Section 09	Applicable Model/s 1998-00 Millenia	Subject LOW FUEL WARNING LIGHT "ON" - ONLY 10-13 GALLONS OF FUEL CAN BE PUMPED INTO TANK	Bulletin No. 003/00R
			Issued 03/09/00
			Revised 10/18/00

- This bulletin supersedes 09-003/00. The APPLICABLE MODEL(S)/VINS have changed.

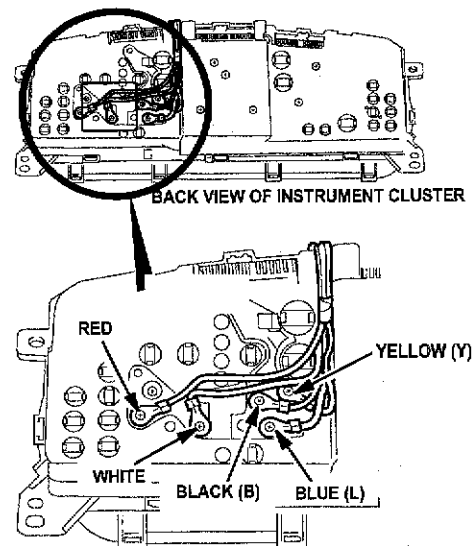
- Remove print plate No. 2 and combination meter from the instrument cluster.

- Be careful not to scratch the instrument cluster front glass during this procedure.

- Install modified print plate No. 2 and the combination meter in the same location.
- Connect print plate No. 2 terminal wires on back of instrument cluster as shown:
